SAFETY DIRECTIVE 00001

Date Released:	July 8, 2020 (Revision 1 – Added servo tray identification) May 14, 2020 (Initial Release)
Date Effective:	July 8, 2020
Subject:	Pitch trim assembly inspection and modification
Affected Models:	RV-12, RV-12iS SLSA: Serial Numbers 12001 to 12086 ELSA: Any aircraft including an Empennage Kit shipped on or before 05/12/2020
Required Action:	Inspect the pitch trim motor shaft for straightness. Determine the model number of the installed trim motor. Determine the part number of the installed servo tray. Examine and ensure the F-1294B-1 lower tailcone fairing does not contact the trim servo linkage. If an ES MSTs-T3-7A-2 trim unit is installed, replace with the newer model unit, bushing, and F-1287A-1 Servo Tray once the life limit is reached, per the time of compliance below. Bag 2670 is also required. If an ES MSTs-B6-7T-165 is installed with F-1287A-1, add part BUSH-BS.188X.313X.222 per the time of compliance below. If an ES MSTs-B6-7T-165 is installed with F-1287A, replace F-1287A with F-1287A-1, and add part BUSH-BS.188X.313X.222 per the time of compliance below. Bag 2670 is also required.

FIGURE 1: FATIGUE LOCATION

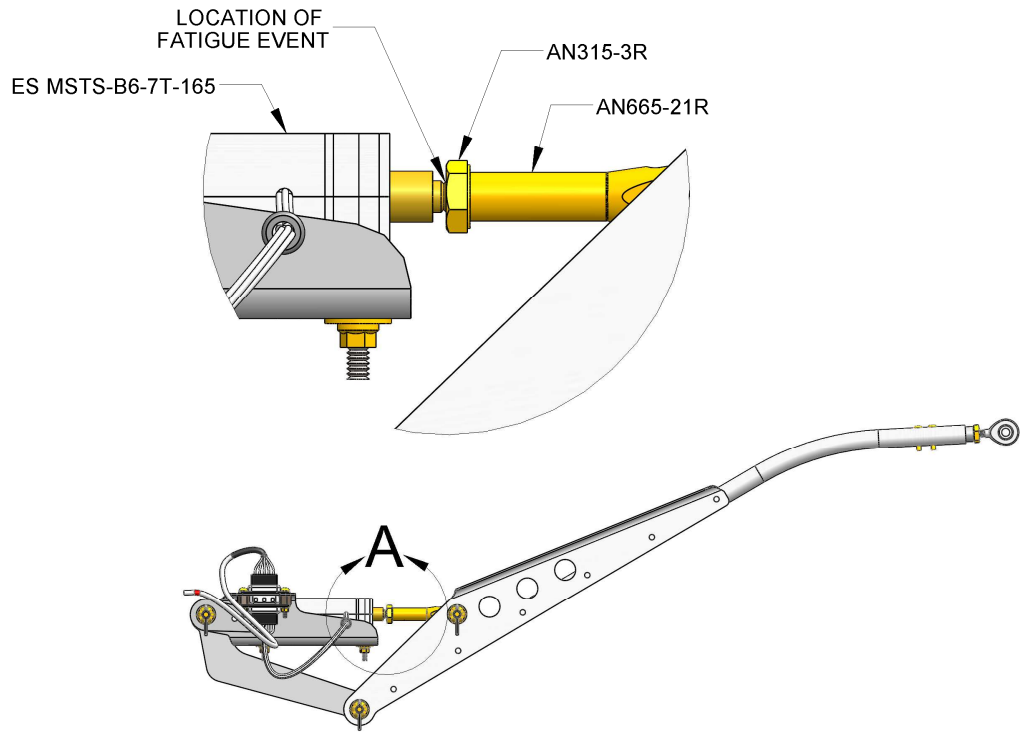
The described failure occurred in the threaded portion of the trim motor shaft, flush with the nut that tightens against the clevis. See Figure 1 below.

A test was then conducted in which the shaft was bent prior to starting the load cycle test. The bent shafts failed after a very high number of cycles at maximum load, in a manner similar to the failure of the trim motor in the field. As a result, Van's has determined that all trim motor shafts must be inspected for straightness before further flight. If the shaft is found to be bent, the trim motor unit must be replaced. A bent shaft should not be straightened and left in service. Analysis has shown that once a shaft is bent, small microcracks can occur in the base of the threads, which would eventually grow and result in a complete failure of the shaft.

Note that normal operational aircraft loading does not cause the shaft to bend. Damage to the shaft could potentially occur during assembly or inspection of the aircraft (for example, due to the application of a side load or if the trim motor was dropped) or if an individual pushed on the anti-servo tab with significant and substantial force (note that this area is marked "NO PUSH" via a placard located on the AST).

Step 2: Inspect the threaded portion of the trim motor shaft. Determine if the shaft is bent. See Figure 1 below and KAI Section 11 for the RV-12 or KAI Section 11iS/U for the RV-12iS. If the shaft is bent, remove and replace the trim motor, add the bushing and replace F-1287A servo tray with the F-1287A-1. If the trim motor has accumulated 1000 hours time in service, replace the trim motor and tray with part number ES MSTS-B6-7T-165 and F-1287A-1, add the bushing, and ensure installation is compliant with the remaining steps in this document below.

Step 2: Inspect the threaded portion of the trim motor shaft. Determine if the shaft is bent. See Figure 1 below and KAI Section 11 for the RV-12 or KAI Section 11iS/U for the RV-12iS. If the shaft is bent, remove, and replace the trim motor.

FIGURE 2: ES MSTs-T3-7A-2 LIFE LIMITED MOTOR

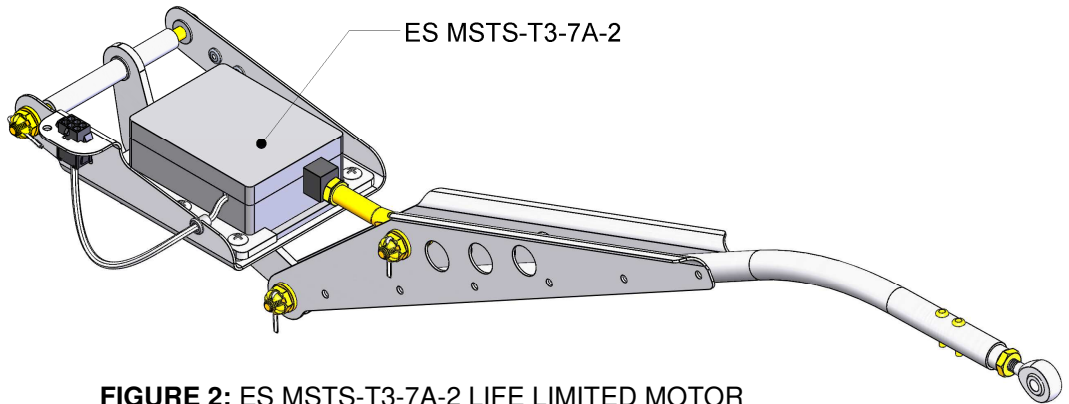
Older ES MSTS-T3-7A-2 trim motors incorporate a shaft without a shoulder. In addition, the entire shaft is threaded. As a result use of the new bushing mentioned above is not applicable. Through this Safety Directive, Van's is instituting a 1000-hour time-in-service life limit on the ES MSTS-T3-7A-2 trim motor design when installed in the RV-12/12iS. This limit is based on the results of the extensive fatigue testing that was conducted at Van's Aircraft. Any aircraft incorporating this older trim motor unit where the shaft is bent or the unit has reached 1000 hours accumulated flight time in service is directed to replace the unit with part number ES MSTS-B6-7T-165, F-1287A-1 Servo Tray, and bushing described in this document. The manufacturer of the trim motor unit, Ray Allen Company, has established a lower-cost return/exchange program for RV-12/12iS customers with a damaged or timed-out T3-7A trim unit. Cost to the owner is \$90 plus shipping. You may contact info@rayallencompany.com to arrange an exchange.

Time of Compliance:	Aircraft with ES MSTs-T3-7A-2: Inspect the trim motor shaft for straightness before further flight. Replace if bent or if trim unit time in service exceeds 1000 flight hours. Aircraft with ES MSTs-B6-7T-165 and F-1287A-1: Inspect the trim motor shaft for straightness before

FIGURE 3: MODIFIED CONFIGURATION

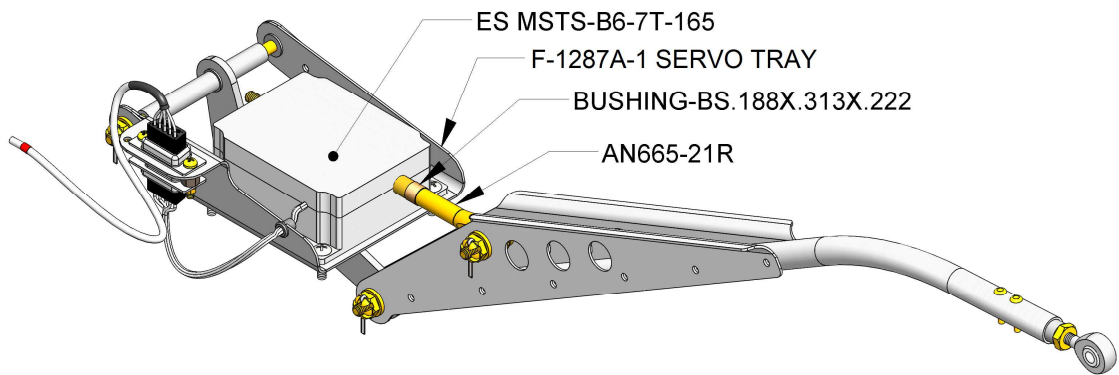
To resolve this potential risk, a bushing must be installed between the clevis and the shoulder on the ES MSTS-B6-7T-165 trim motor shaft. This bushing will transfer any bending load in the clevis safely to the shoulder of the shaft, which will prevent the threaded portion of the shaft from flexing and potentially fatiguing locally at the thread behind the nut. Van's strongly recommends installation of this bushing before or at the next condition inspection, and mandates that it be installed no later than 1,000 hours time in service.

If ES-MSTS-B6-7T-165 was installed in a F-1287A Servo Tray during a previous servo replacement, stabilator to anti-servo tab interference will result if the described bushing is installed. Therefore, F-1287A must be replaced by F-1287A-1 when the bushing is installed. To identify F-1287A-1 see Figure 3 below.

Step 6: Using the new KAI Section 11iS/U downloaded from the Van's Aircraft web site install the BUSH-BS.188X.313X.222 and clevis rod end onto the ES MST5-B6-7T-165 Trim Motor shaft. If the F-1287A Servo Tray was previously being used it must now be replaced with the F-1287A-1 Servo Tray. Re-attach the clevis rod end to the Trim/Servo Pushrod Assembly.
